## Economic and Social Council

Joint Meeting of Experts on the Regulations annexed to the  
European Agreement concerning the International Carriage  
of Dangerous Goods by Inland Waterways (ADN)  
(ADN Safety Committee)

Twenty-sixth session  
Geneva, 27–30 January 2015

### **Report of the Joint Meeting of Experts on the Regulations annexed to the European Agreement concerning the International Carriage of Dangerous Goods by Inland Waterways (ADN Safety Committee) on its twenty-sixth session<sup>1</sup>**

Examples of stowage and segregation of containers

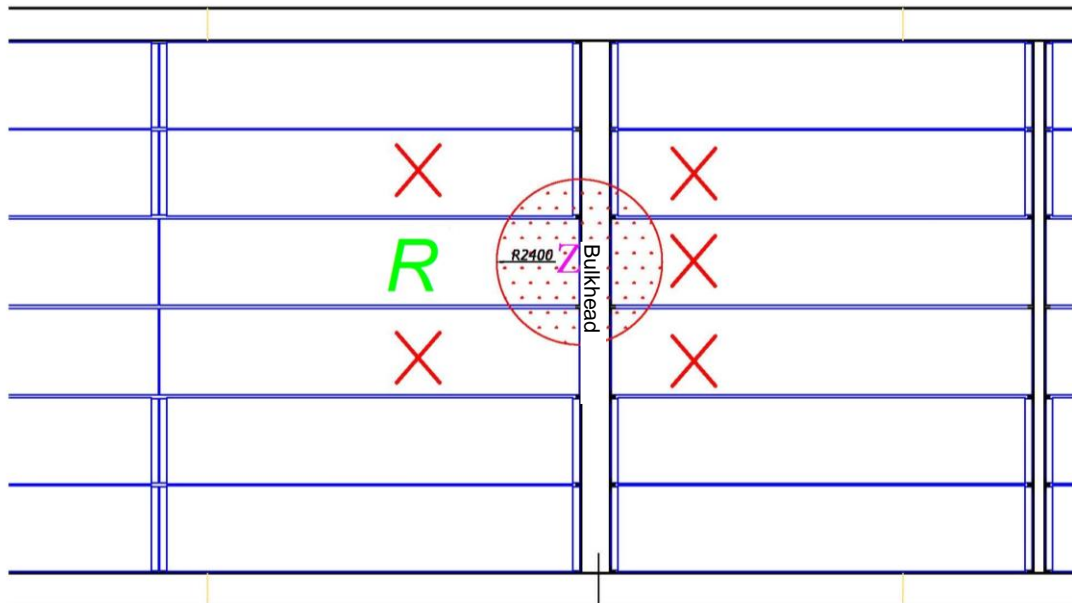
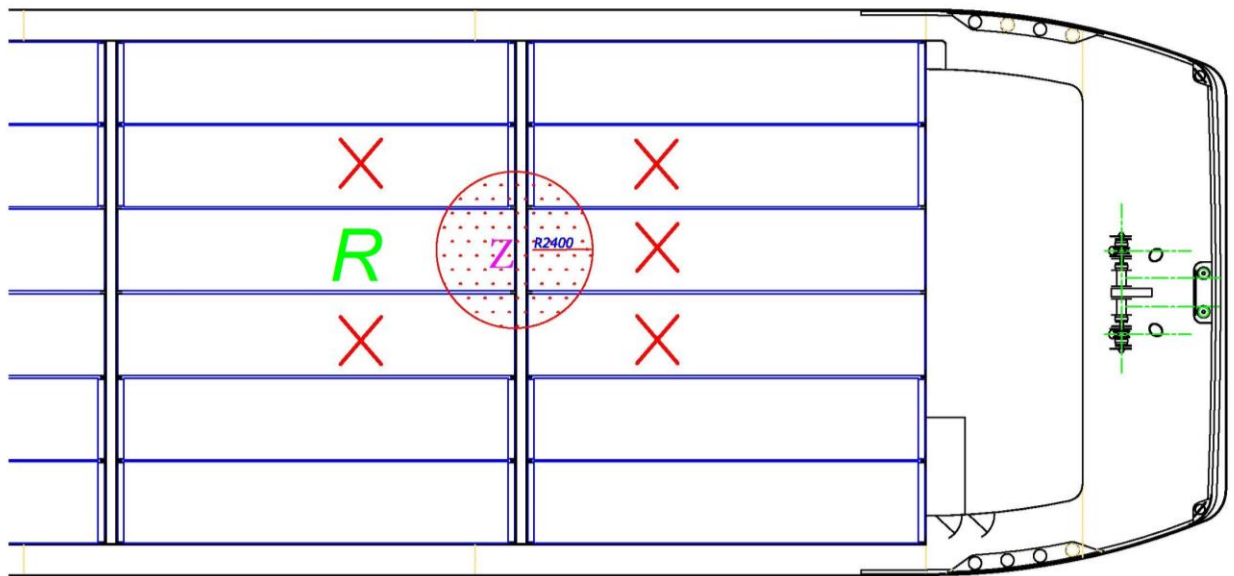
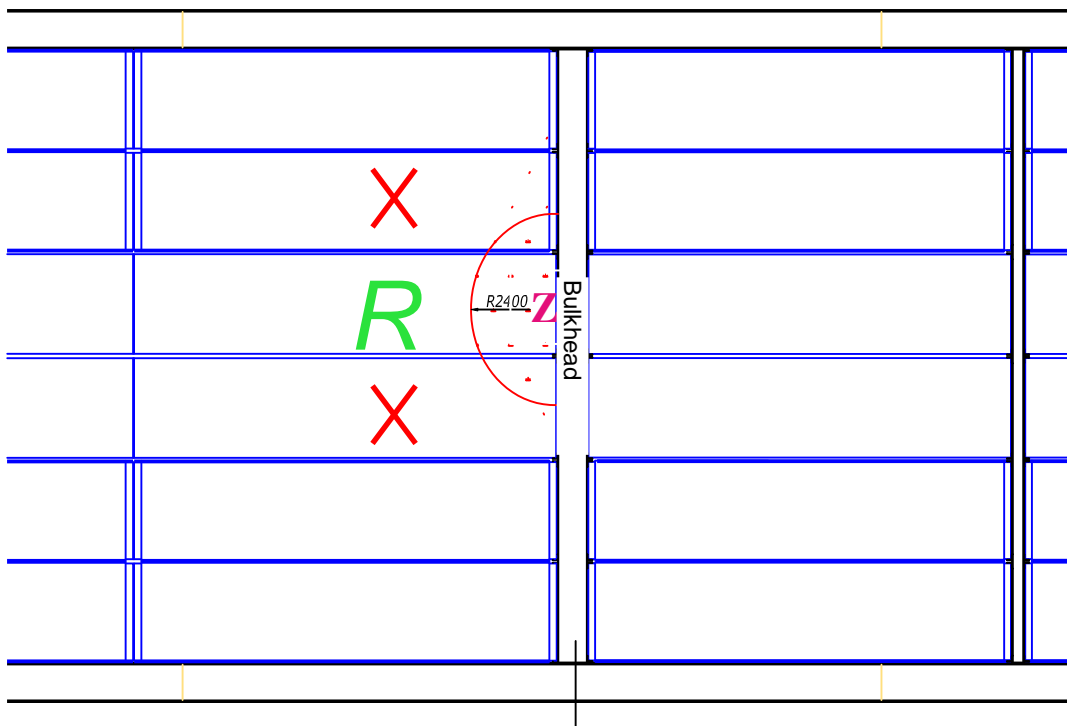
7.1.4 Insert a new paragraph 7.1.4.4.4 to read as follows:

"7.1.4.4.4 The electrical equipment fitted to the outside of a closed container may be connected with removable electrical cables in accordance with the provisions of 9.1.0.56 and be put into operation provided that:

- (a) Such electrical equipment is of a certified safe type; or
- (b) Such electrical equipment is not of a certified safe type but is separated sufficiently from other containers containing substances of:
  - Class 2 for which a label No. 2.1 is required in column (5) of Table A of Chapter 3.2;

- Class 3, packing group I or II;
- Class 4.3;
- Class 6.1; packing group I or II, with an additional hazard of Class 4.3;
- Class 8, packing group I, with an additional hazard of Class 3; and
- Class 8, packing group I or II, with an additional hazard of Class 4.3.

This condition is deemed to be met if no container containing the above-mentioned substances is stowed within an area of cylindrical form with a radius of 2.4 m around the electrical equipment and an unlimited vertical extension.

This condition does not apply if containers with electrical equipment which is not of a certified safe type and containers containing the above-mentioned substances are stowed in separate holds.
